STRATHFIELD LOCAL PLANNING PANEL MEETING AGENDA

TO: Strathfield Local Planning Panel Meeting - 3 November 2022
 REPORT: SLPP – Report No. 31
 SUBJECT: S8.2-DA2022.81- 20 KARUAH STREET STRATHFIELD
 LOT: 188 DP: 15259
 DA NO. S8.2-DA2022.81

Property:	20 Karuah Street STRATHFIELD Lot: 188 DP: 15259 S8.2-DA2022.81
Proposal:	S8.2 Review of the determination of DA2022/81 for the purpose of demolition of existing structures and construction of a two-storey dwelling with basement, swimming pool and associated aworks.
Applicant:	A Wu
Owner:	X Luo
Date of lodgement:	16 September 2022
Notification period:	27 September 2022 - 12 October 2022
Submissions received:	Two (2) written submissions received
Assessment officer:	L Gibson
Estimated cost of works:	\$1,583,094.00
Zoning:	R2-Low Density Residential - SLEP 2012
Heritage:	No
Flood affected:	No
Local Planning Panel Criteria	Refused at IDAP
RECOMMENDATION OF OFFICER:	REFUSAL

Figure 6: Proposed Basement Plan

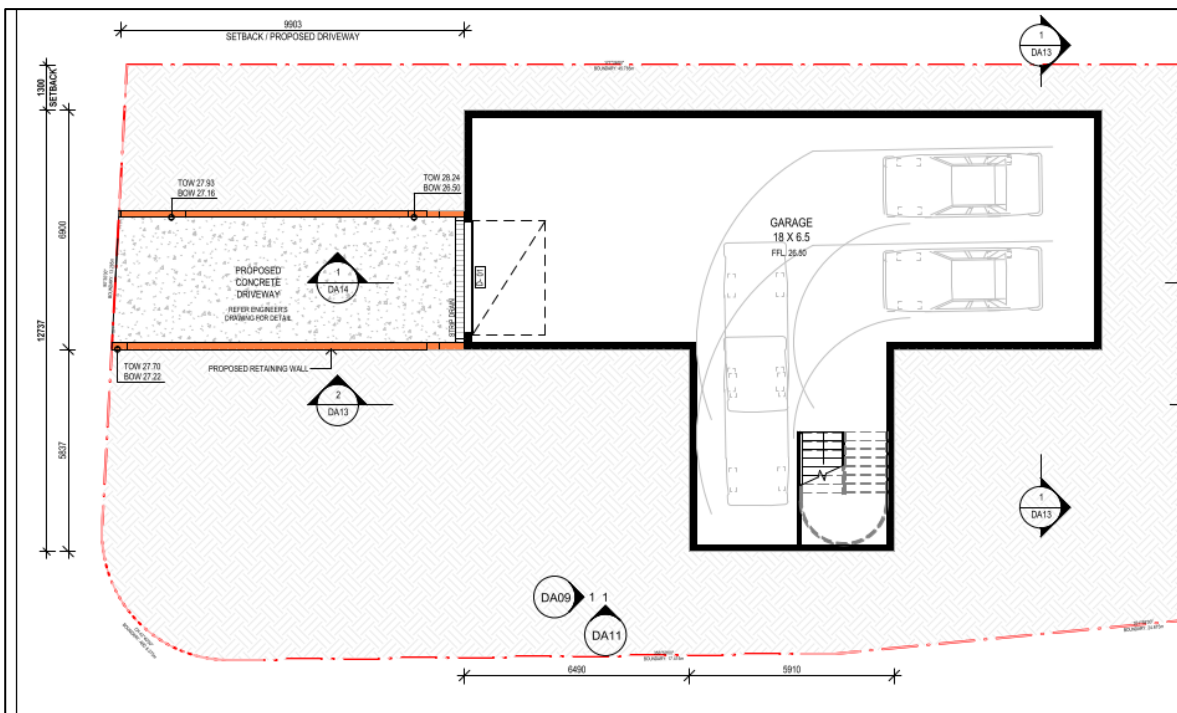
With regard to the above, the proposal has remained relatively unchanged with the exception of the driveway crossover location and basement driveway. It is noted that the refused basement design plan was not updated in the initial assessment so to reflect the revised basement design as shown on the refused site plan. Notwithstanding, whilst the revised design appears to achieve an appropriate distance from the neighbouring tree, the driveway is in direct conflict with the Council street tree.

Figure 30 – Overlay of ground floor plan and survey

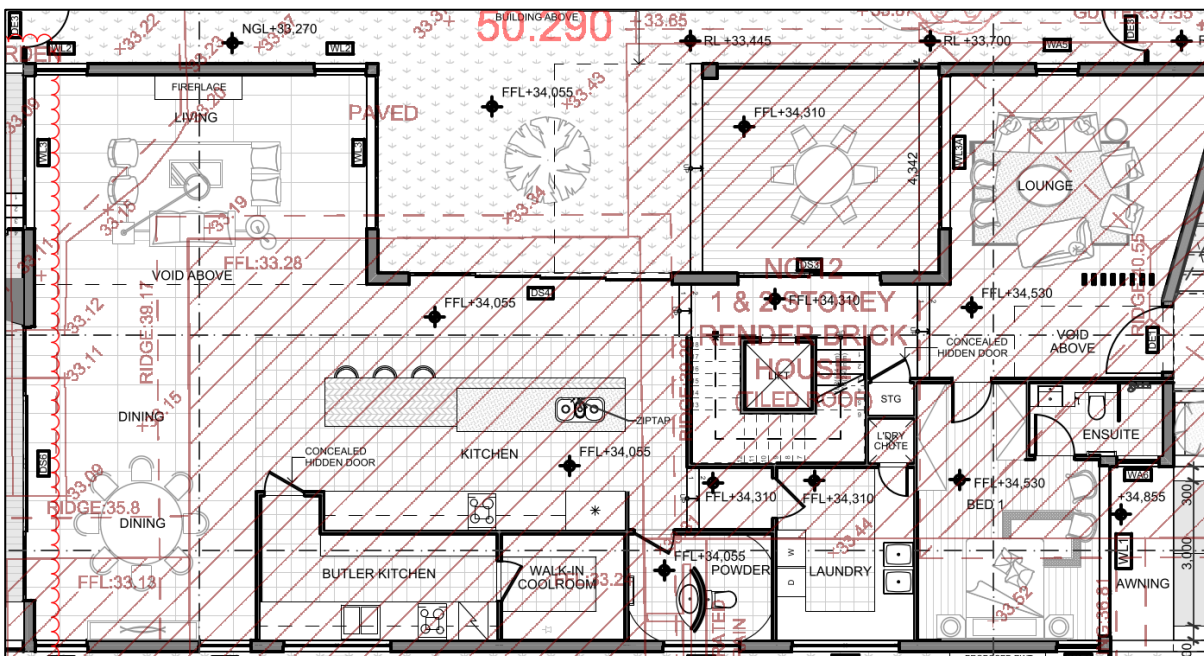
A reason for refusal in the NOD from March 2022 was the unacceptable bulk and scale of the development. As outlined above, this was largely a result of the basement floor area being included in GFA due to a protrusion of the basement by more than 1m. The image below overlays the survey plan and proposed ground floor plan subject of this assessment, demonstrating that the finished floor level of the ground floor is less than 1m from existing ground level at all points.

Notwithstanding, the proposal does incorporate a large void adjoining the western boundary, that while excluded from FSR calculations, makes a contribution to bulk and scale. The proposed outcome has been accepted on merit as the final design incorporates a skillion roof over the void, mitigating the bulk of the building in this location.

Figure 32 – Site Plan showing length of adjoining dwellings

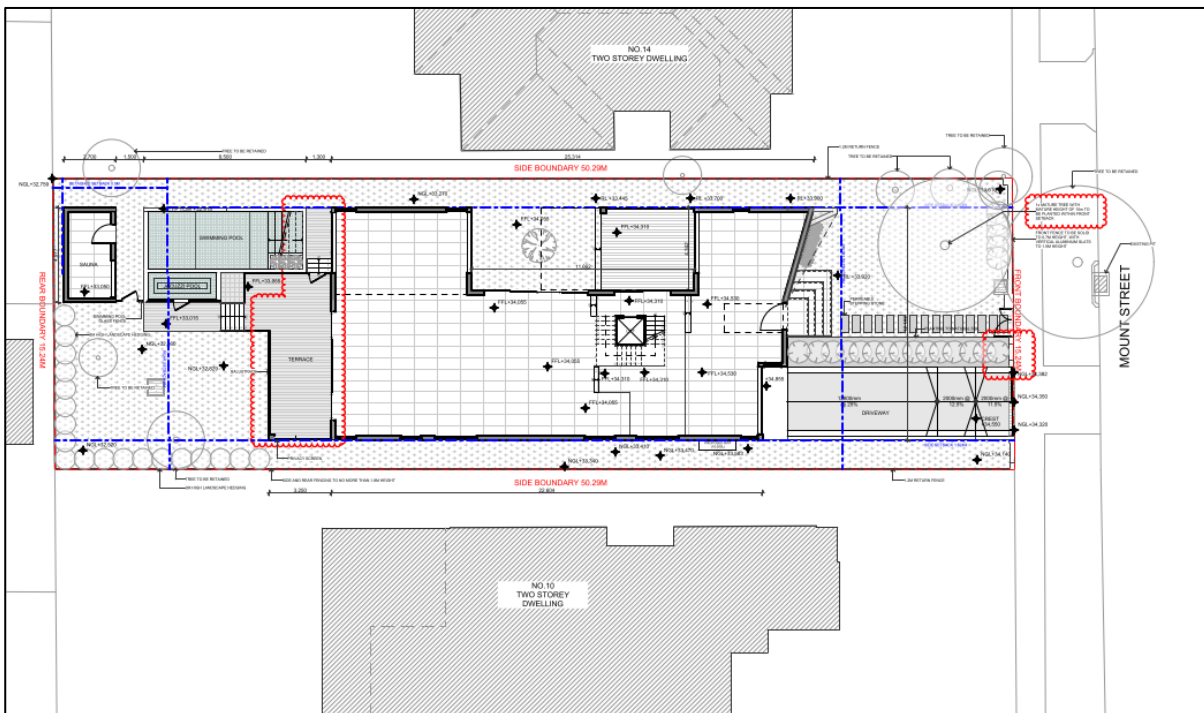
The development incorporates a number of privacy measures along the western elevation, at both level 1 (obscured glass) and at ground level (fixed louvres to the living room windows).

Finally, conditions of consent will require the lowering of the western alfresco area, which will improve privacy for both parties.
